Subject: **Comments on Incorporation by Reference of American Society of Mechanical Engineers Codes and Code Cases, 10 CFR Part 50, RIN 3150-AK22, Docket ID NRC-2018-0290**

ASME Comments on 10 CFR 50.55a Proposed Rule, Federal Register, Vol. 86, No. 57, pp. 16087-16114, Friday, March 26, 2021, RIN 3150-AK22, Docket ID NRC-2018-0290

ASME Section XI Working Group on Operating Plant Criteria Comments to proposed Section XI condition: “Prohibitions and Restrictions on use of IWB-3510.4(b), IWC-3510.5(b), Table A-4200-1, and Table G-2110-1”

ASME Comments on 10 CFR 50.55a(b)(2)(xl) Condition in the Proposed Rule, Federal Register, Vol. 86, No. 57, pp. 16087-16114, Friday, March 26, 2021, RIN 3150-AK22, Docket ID NRC-2018-0290

Figure 1, K_{IC} vs $T - RT_{NDT}$ for ASTM A-533 Type B Class 2 [Hawthorne, 1972]

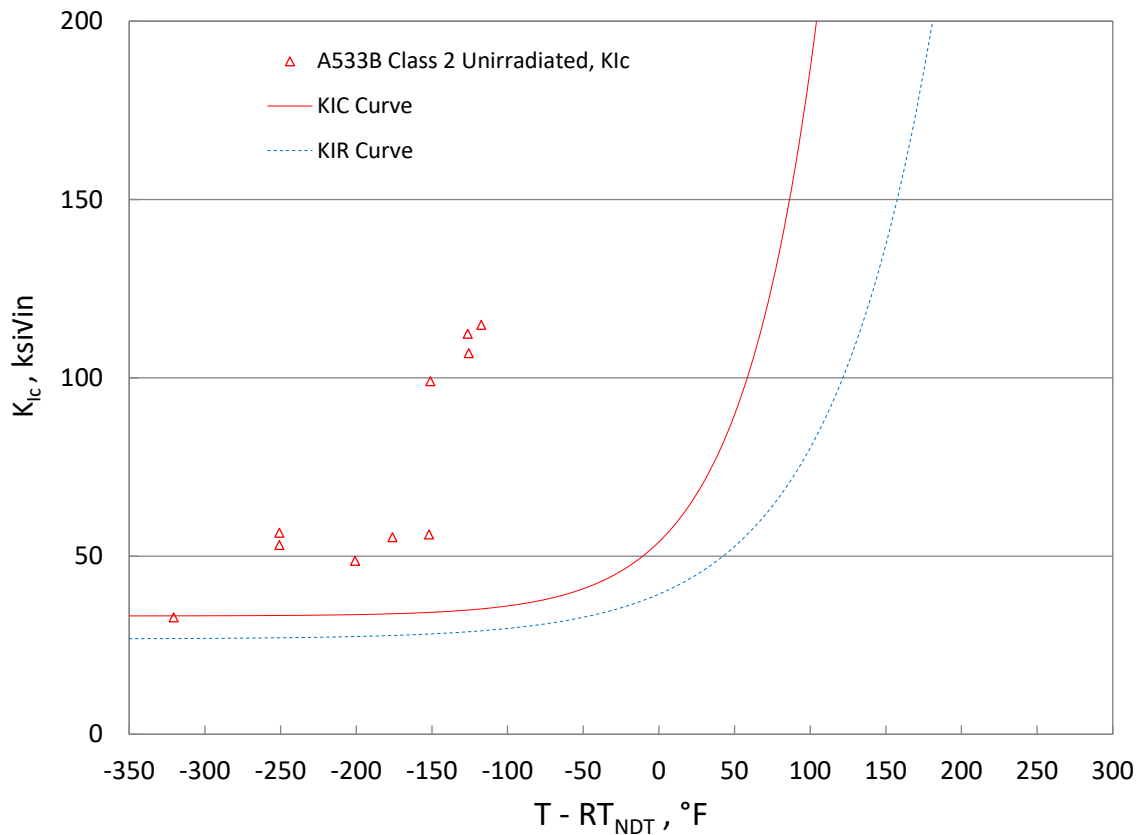
Figure 1 plots the unirradiated K_{Ic} data assuming RT-NDT = 0°F. The unirradiated T-NDT was 0°F; RT-NDT was not reported because RT-NDT was first adopted by Section III, NB-2300 in 1973. Judging from the unirradiated Charpy curve, the unirradiated RT-NDT per NB-2300 definition may be higher than T-

NDT. If RT-NDT were higher than 0°F, the plotted K_{Ic} test data in Figure 1 would shift toward the left, resulting in higher margin against the minimum K_{Ic} curve than shown in Figure 1. Therefore, the K_{Ic} test data exceeded the minimum K_{Ic} curve in Figure G-2210-1 and Figure A-4200-1.

The above test data for SA-533 Type B Class 2 were not included in PVP2019-93988; they provide additional support to the PVP2019-93988 conclusion that the four grades of ferritic steels can be considered as one group for the applicability of the minimum K_{Ic} curve in Section XI Appendix A and Appendix G. In light of the additional test data, the proposed condition (restriction or prohibition) on SA-533 Type B Class 2 is unnecessary.

Figure 2, K_{Ic} and K_{Id} vs T-RT_{NDT} for SQV2B [Hayashi, 2004]

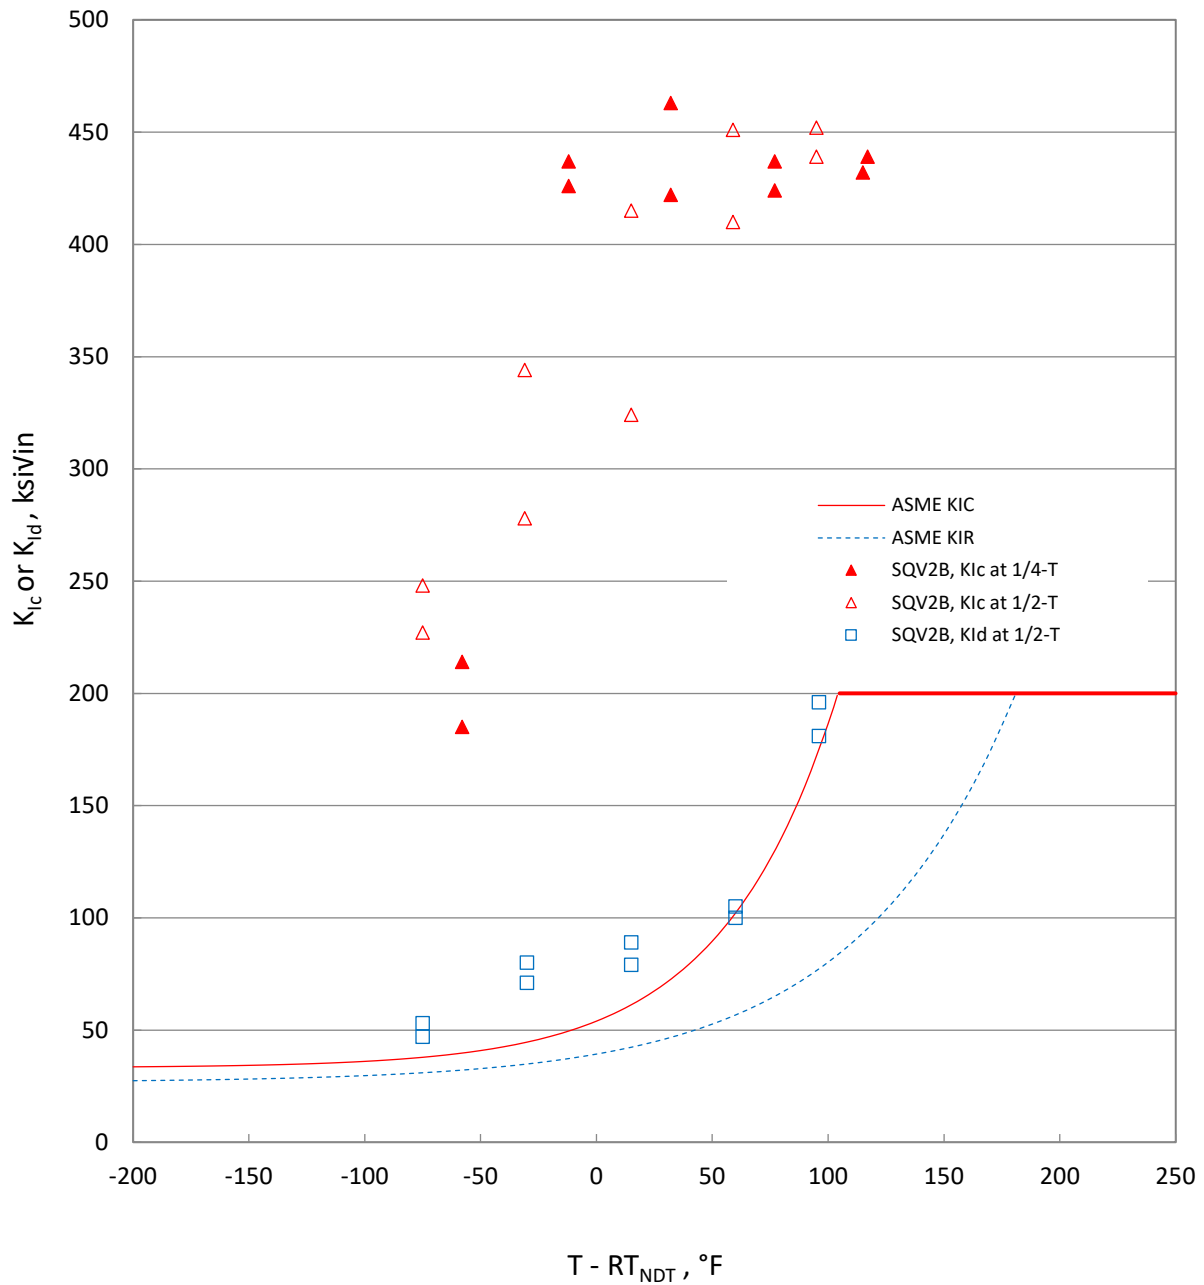
Figure 2 plots the K_{Ic} and K_{Id} test data. The RT-NDT was -33°C (-27°F). Figure 2 shows that the K_{Ic} test data exceeded the minimum K_{Ic} curve in Figure G-2210-1 and Figure A-4200-1. The K_{Ic} test data were significantly above the K_{Id} test data, and even the K_{Id} test data met the minimum K_{Ic} curve.
